3 BHK Unit 3) & (Unit 1)
Typ Floor
10/8/2022

PDA.
3BHK (Unit 2)
4/8/2022

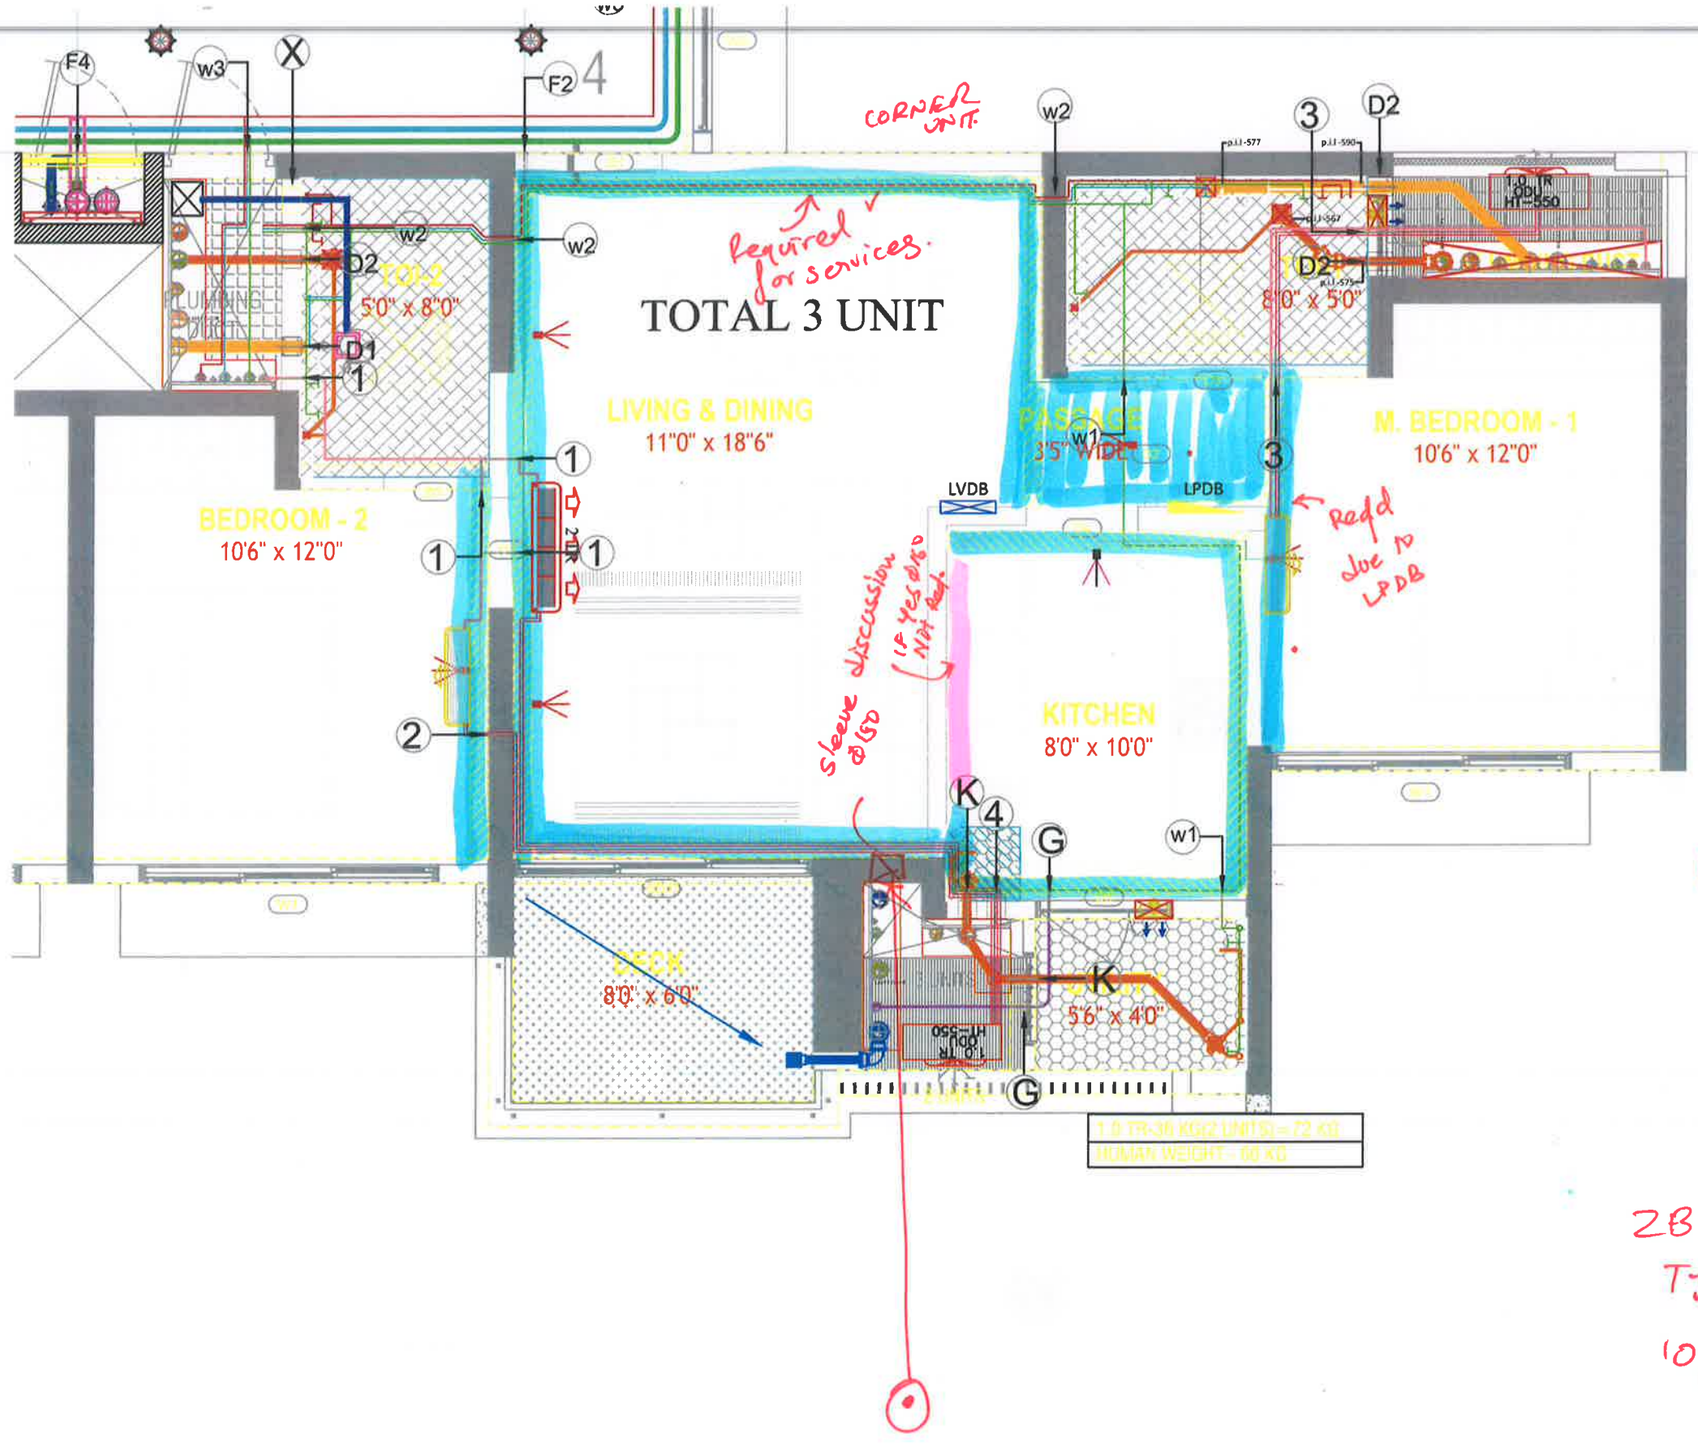
TOTAL 3 UNIT
CORNER UNIT
required for services.
LIVING & DINING
11'0" x 18'6"
BEDROOM - 2
10'6" x 12'0"
PASSAGE
3'5" WIDE
M. BEDROOM - 1
10'6" x 12'0"
KITCHEN
8'0" x 10'0"
DECK
8'0" x 6'0"
TOI-2
5'0" x 8'0"
TOI-1
5'6" x 4'0"
LVDB
LPDB
Reqd due to LPDB
Sleeve discussion
If yes dia 150 NA Req.
If 150ϕ Sleeve can be provided in the location indicated then the bulkhead can be avoided in kitchen (units 4, 5, 10 & 11)
2BHK (Unit 4)
Typ. Floor
10/8/2022
1:50

2BHK (units 5)
Typ. Floor
10/8/2022

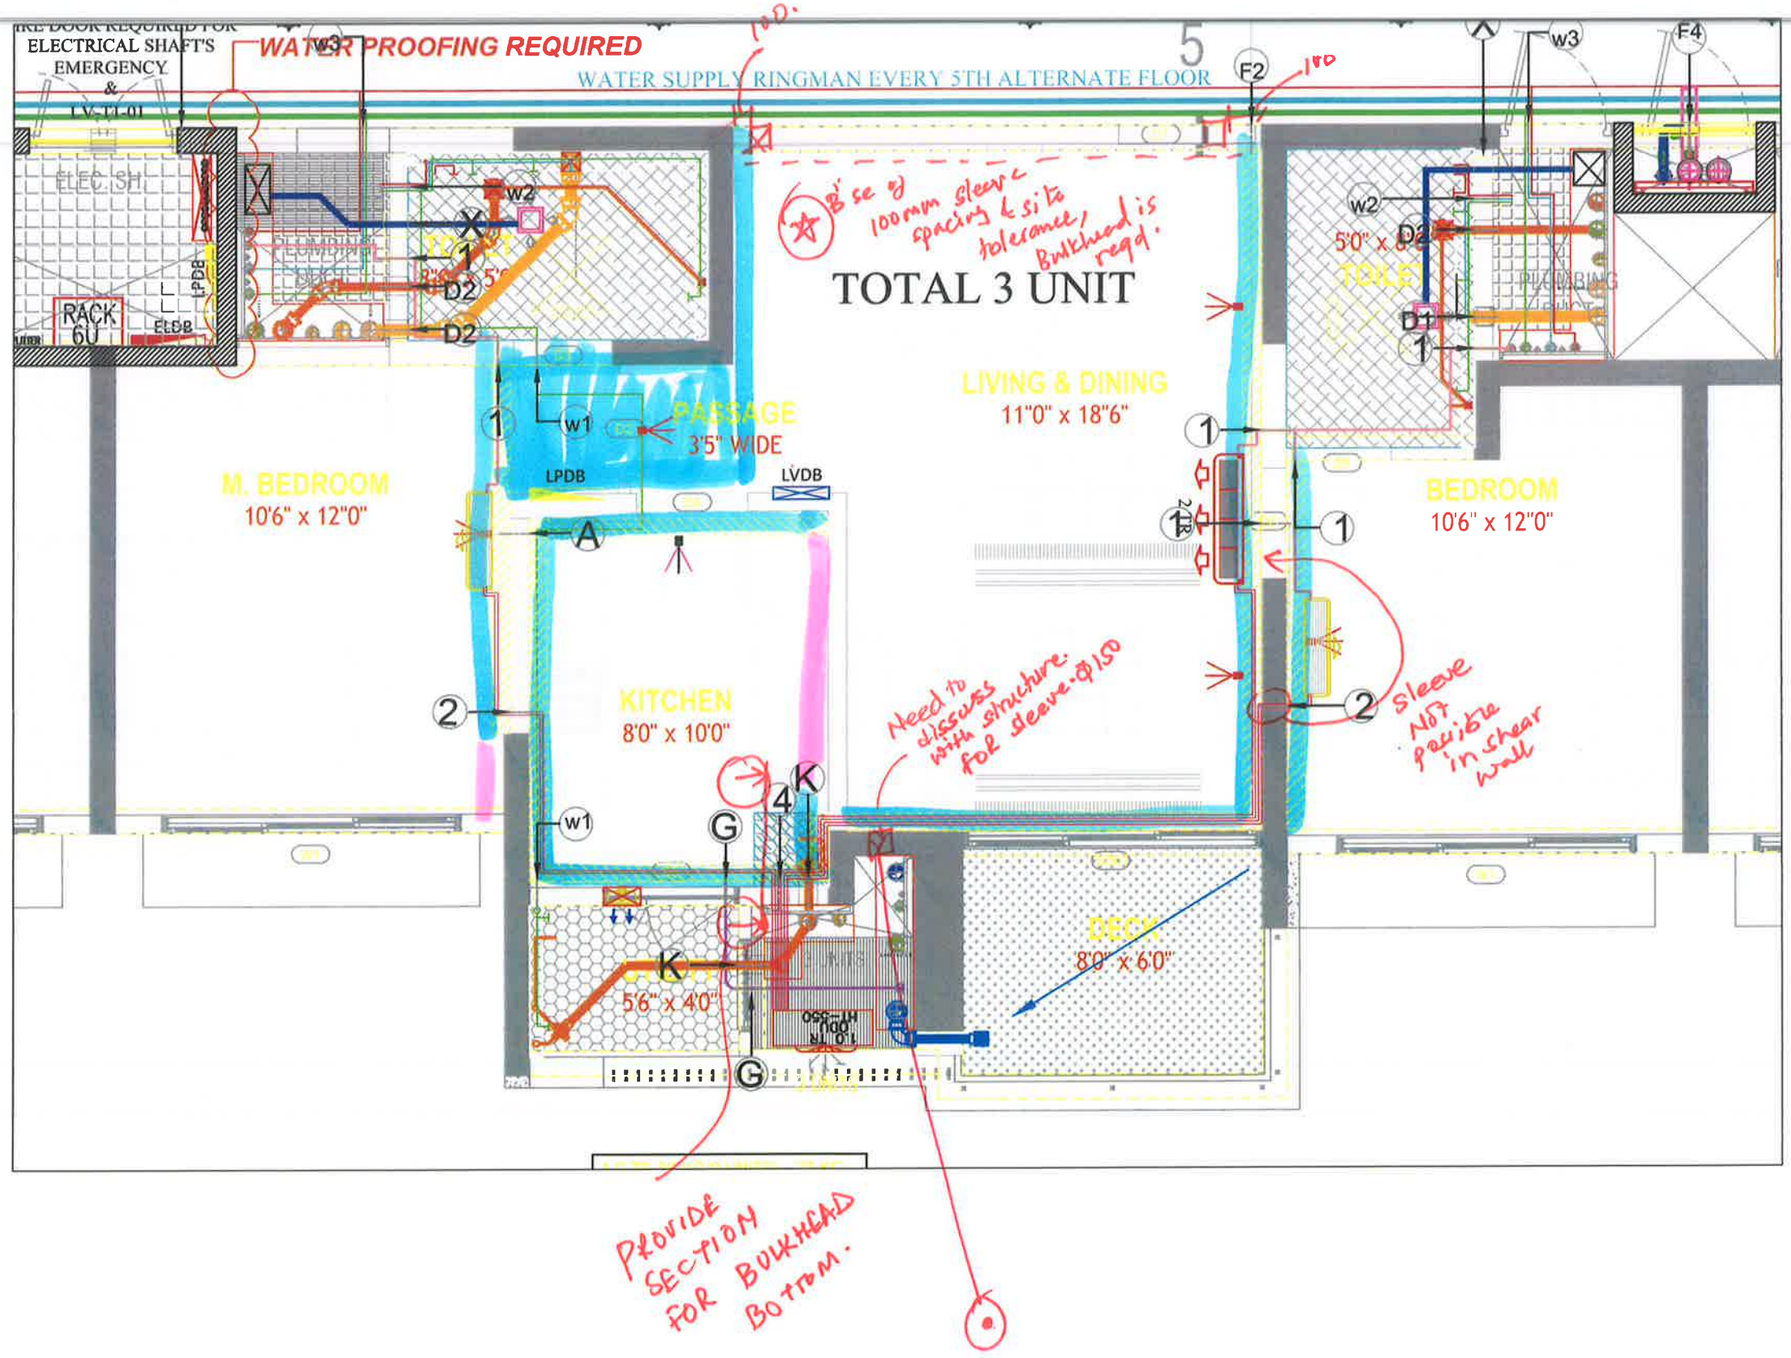
Base of 100mm sleeve spacing & site tolerance, Bulkhead is reqd.

If 150 ϕ sleeve can be provided in the location then one bulkhead can be avoided in kitchen. (units 4, 5, 10 & 11)

Sleeve will be 100 mm away & site tolerance will make the bulkhead +200 mm

ZB14K (Unit 6)
Typ. Floor
10/8/2022

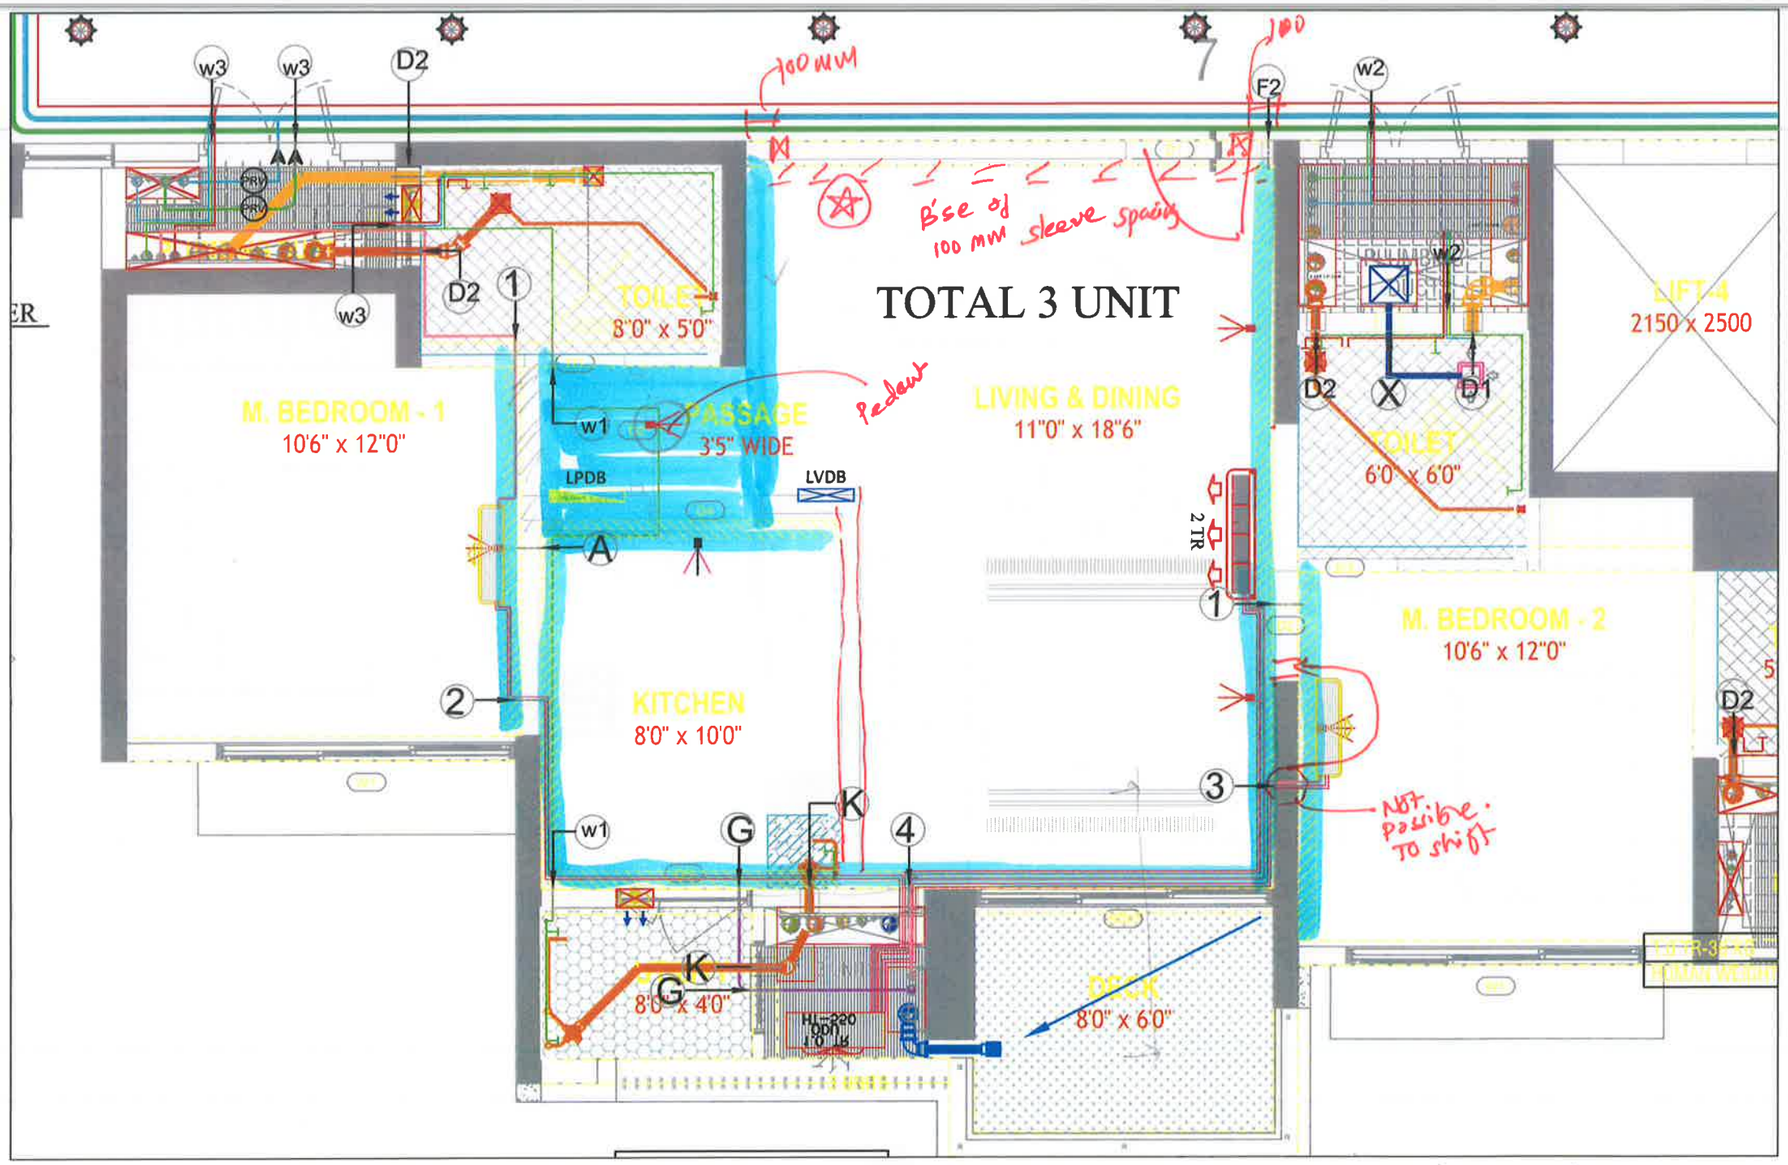
SHAFT VENTILATION (TYPICAL)
FIRE DOOR REQUIRED FOR
ELECTRICAL SHAFT'S
APARTMENT ELEC SHAFT

WATER PROOFING REQUIRED

ELEC-TT-03
FIRE DOOR REQUIRED FOR
ELECTRICAL SHAFT'S
EMERGENCY
&
LV-TT-01

Pelmet Recpt. of sleeve at corner N/A possible

Sleeve will be 100 mm away ← Site tolerance will make bulkhead +200 mm

THIS CAN BE AVOIDED. SHIFTING ODU & DRAIN. TO UTILITY SHAFT. PLEASE CORRECT.

2BHK (UNIT B)

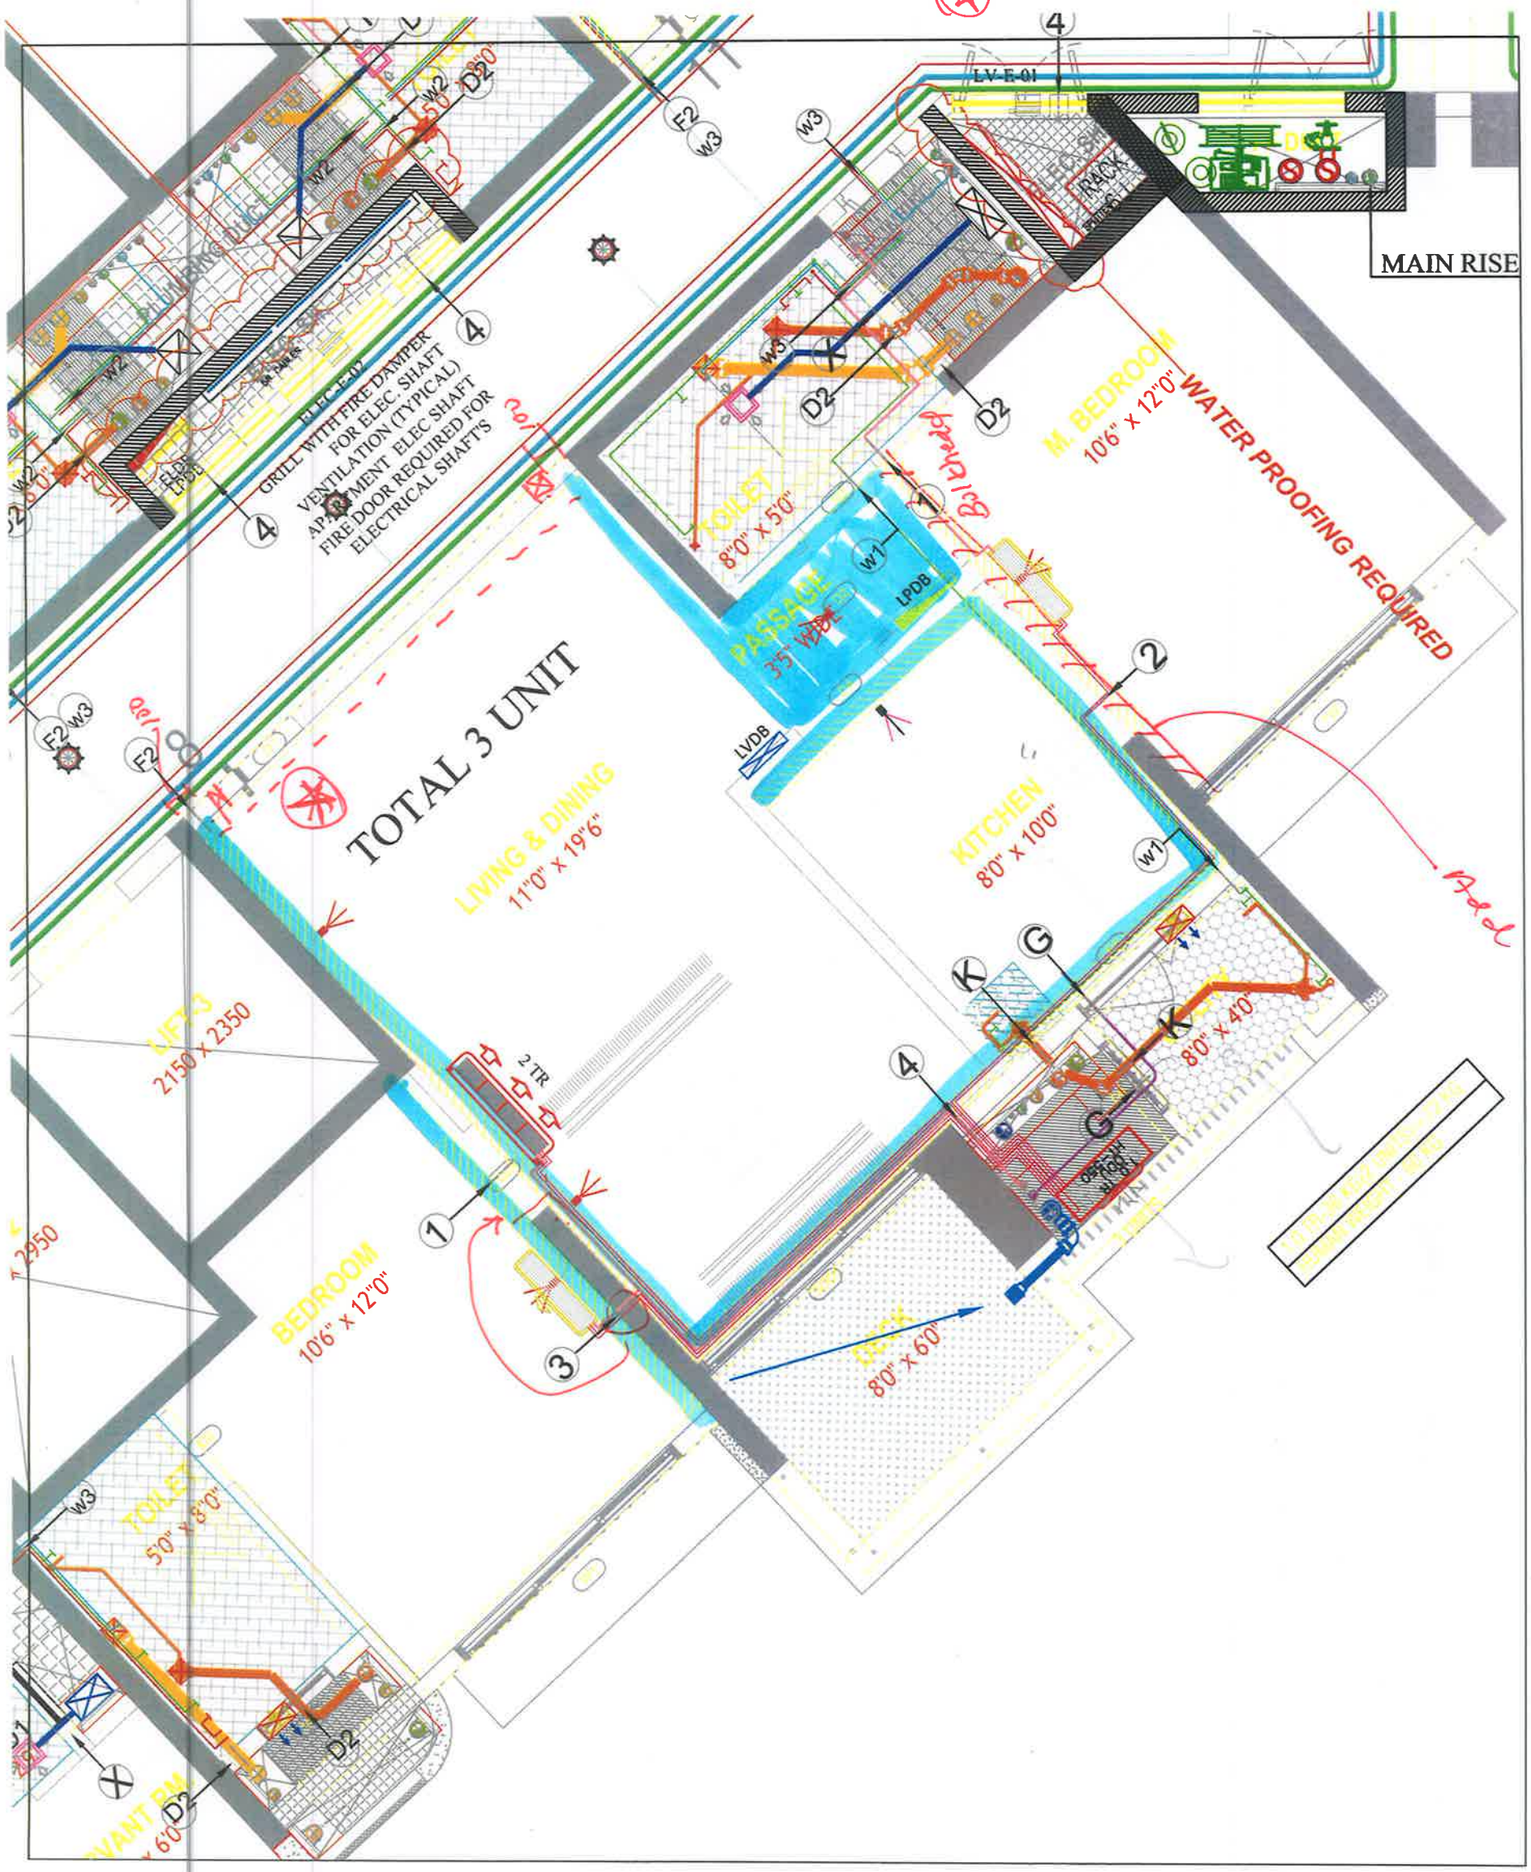
(A) Sleeve will be 100 mm away & site tolerance will make for bulkhead +200mm
